Access Compliance Report

Public Rights-of-Way

(Curb Ramps)

Intersection ID: 19795	Main Street: EMERYWOOD_DR	Cross Street: NETHERWOOD_DR	Location:	W
ADA ID: D660C12D6D6F	Ramp Type: BlendTrans2	Initial Pass/Fail: Fail	Overall Compliance: No	Severity Score: 12.5

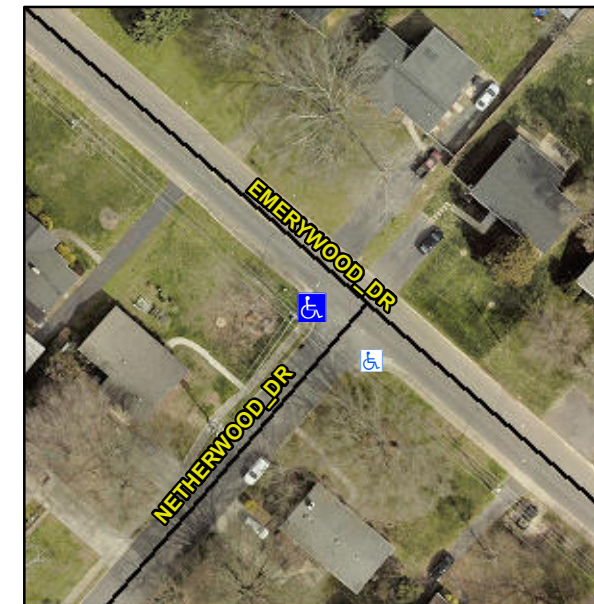
Not Found, R304.5.3

Remove & Replace Curb Ramp With Two New Directional Ramps or Equivalent.
